DOCKETED	
Docket Number:	23-AFC-03
Project Title:	Black Rock Geothermal Project (BRGP)
TN #:	256577
Document Title:	Black Rock Geothermal LLC Responses to CURE Comments on the ICAPCD PDOC
Description:	N/A
Filer:	Lindsey Xayachack
Organization:	Jacobs
Submitter Role:	Applicant Consultant
Submission Date:	5/29/2024 10:08:16 AM
Docketed Date:	5/29/2024

RE: Selected Responses to the California Unions for Reliable Energy Comments on the Preliminary Decision to Grant a Preliminary Determination of Compliance for the Black Rock Geothermal Power Generation Plant

Figure IV.A.2-1
Comparison of Wind Roses
Black Rock Geothermal Project
 Imperial County, California

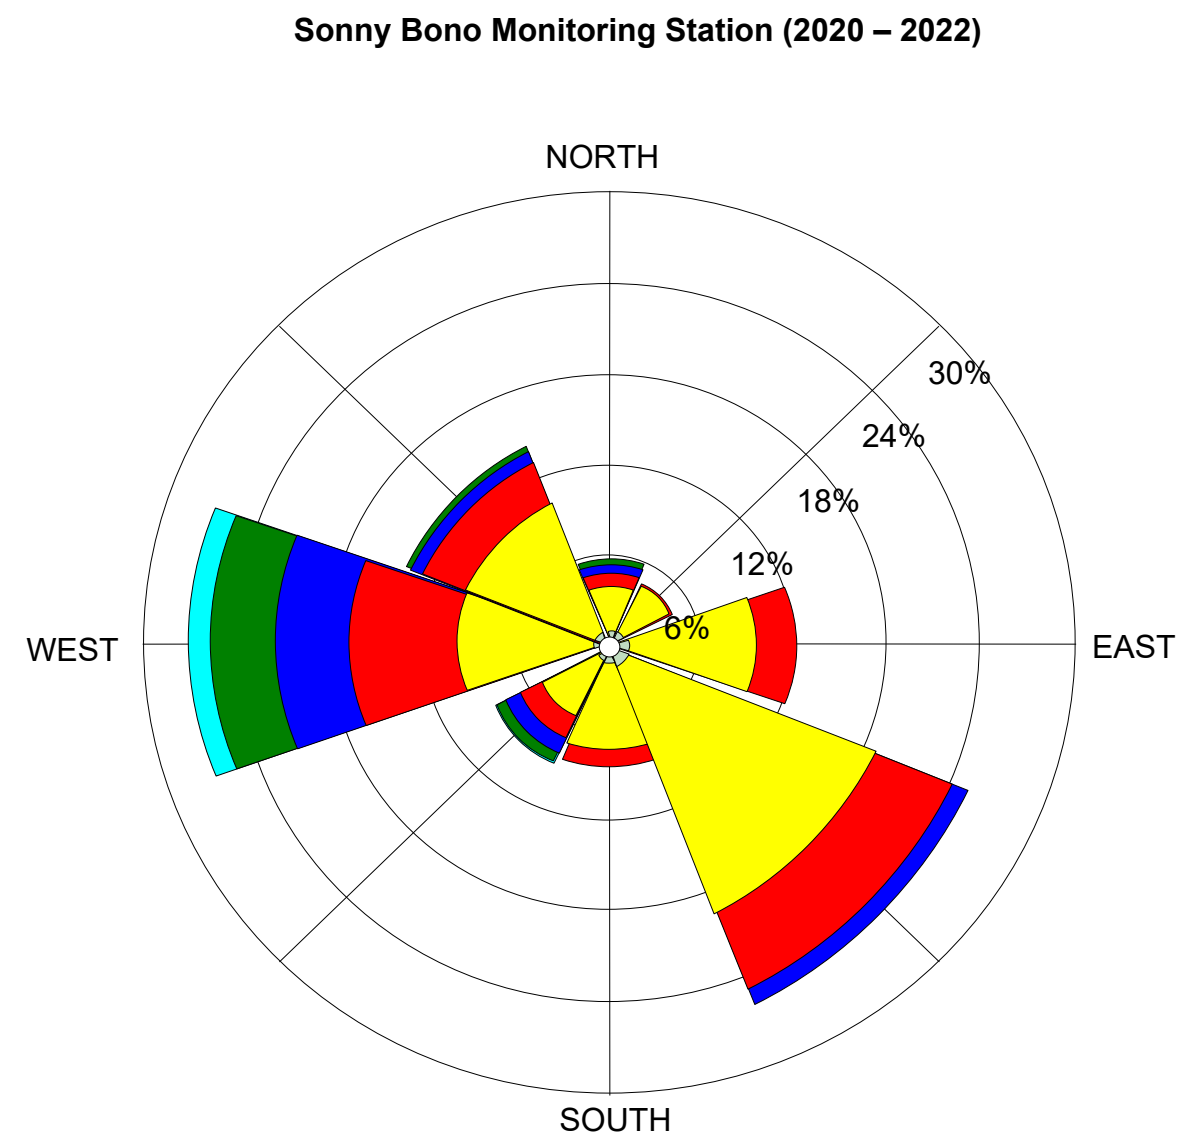
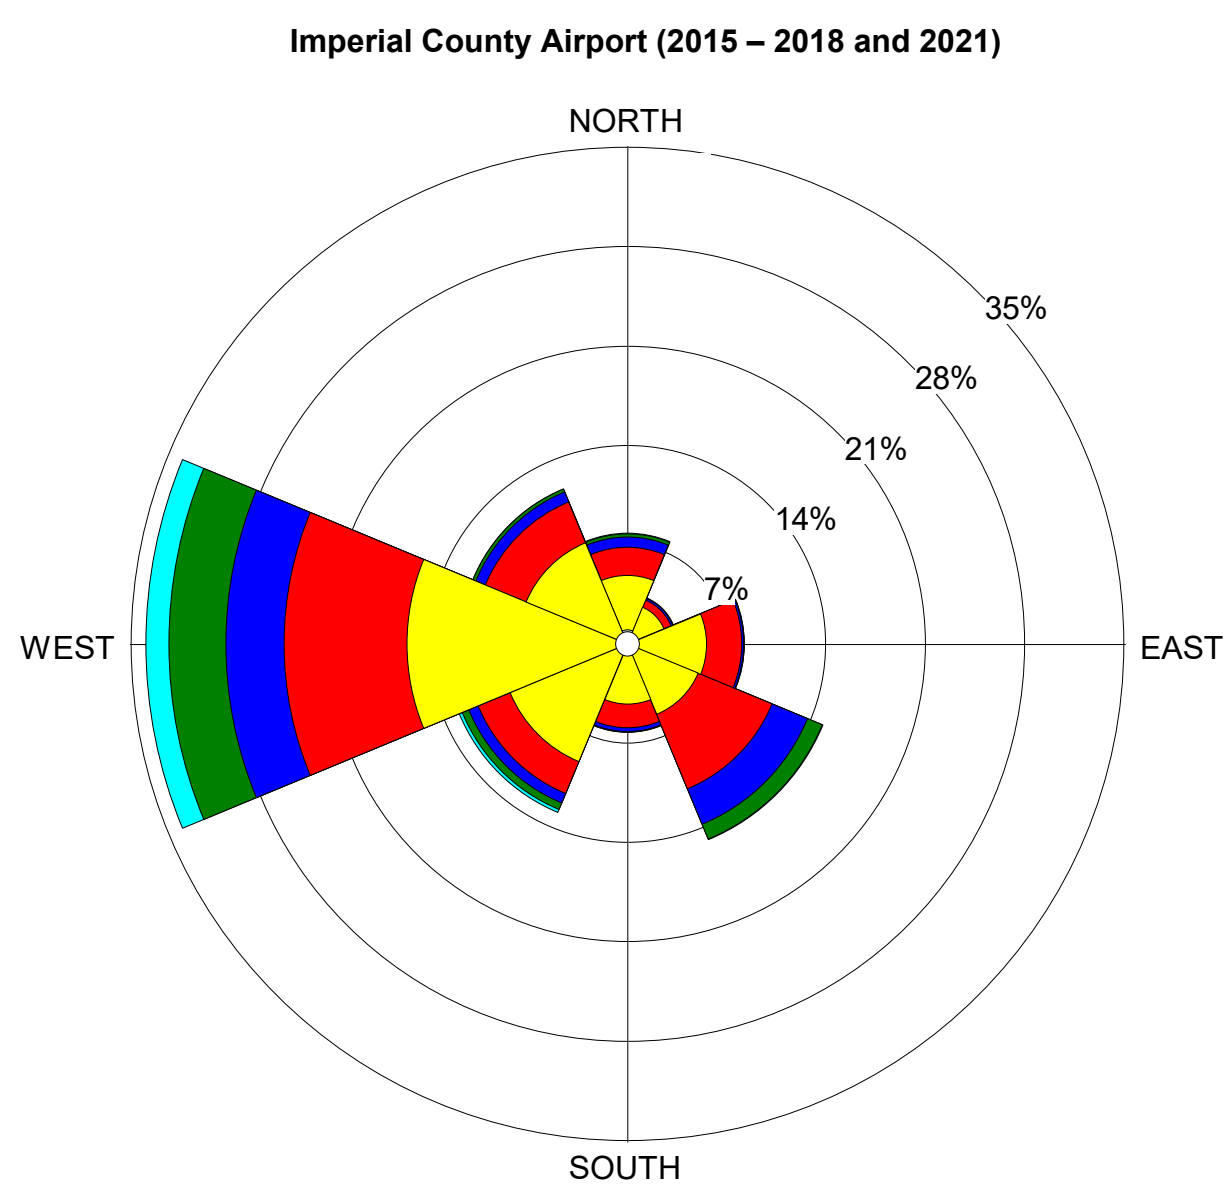
In Section IV, Subsection A.2 of its comments, CURE asserts that the air quality model relied upon by the Air District to determine the project’s compliance with Ambient Air Quality Standards (AAQS) failed to utilize a representative monitoring site for meteorological data and background particulate matter concentrations.⁵ This assertion is incorrect.

First, the dispersion model utilized the most representative, accurate, and reliable meteorological data available, consistent with EPA Guidelines. In particular, the Applicant reviewed the meteorological data collected at the Sonny Bono monitoring station, which is the monitoring station that CURE recommended the Air District analyze within its comments.⁶ Only two years of recent data (2020 and 2022) from that station meet the EPA requirements of 90 percent minimum completeness before substitution on a quarterly basis.⁷ To ensure the worst-case meteorological conditions are adequately represented in the model results, the EPA requires the use of five years of adequately representative National Weather Service (NWS)

In addition, the Sonny Bono monitoring station is not an Automated Surface Observing Systems (ASOS) station, unlike the Imperial County Airport NWS station. ASOS stations are those monitoring stations which collect sub-hourly 1 to 5-minute wind speed and wind direction readings. To reduce the number of calms and missing winds in the surface data, archived 1-minute winds for the ASOS stations can be used to calculate hourly average wind speeds and wind directions, which are used to supplement the standard archive of hourly observed winds processed in the American Meteorological Society/EPA Regulatory Model (AERMOD) Meteorological Preprocessor (AERMET).

Lastly, although the Imperial County Airport is located over 28 miles from the project site, there are no significant geographic features between the two locations, and both are located south/southeast of the Salton Sea. The lack of significant geographic features between the two locations is itself an indicator of representativeness of the Imperial County Airport meteorological data,⁹ but also leads to the expectation that wind speeds and wind directions in the project vicinity are similar to those incurred at the Imperial County Airport. This expected similarity is verified by comparing the wind rose for the Imperial County Airport (for years 2015 to 2018 and 2021) to the wind rose for the Sonny Bono monitoring station (for years 2020 to 2022). As shown in Figure IV.A.2-1, attached hereto, both wind roses share the predominant wind directions from the west and southeast.

Based on the above, the meteorological data collected at the Sonny Bono monitoring station is not more suitable for modeling as the data does not meet the minimum requirements for completeness, and would not be any more representative of the project site than the Imperial County Airport data based on a comparison of wind roses. Furthermore, as an ASOS station, the Imperial County Airport NWS station may provide fewer missing hours of wind speeds and wind directions. For these reasons, the Applicant supports the continued use of the Imperial County Airport NWS station meteorological data, as previously approved both by the ICAPCD and CEC.¹⁰
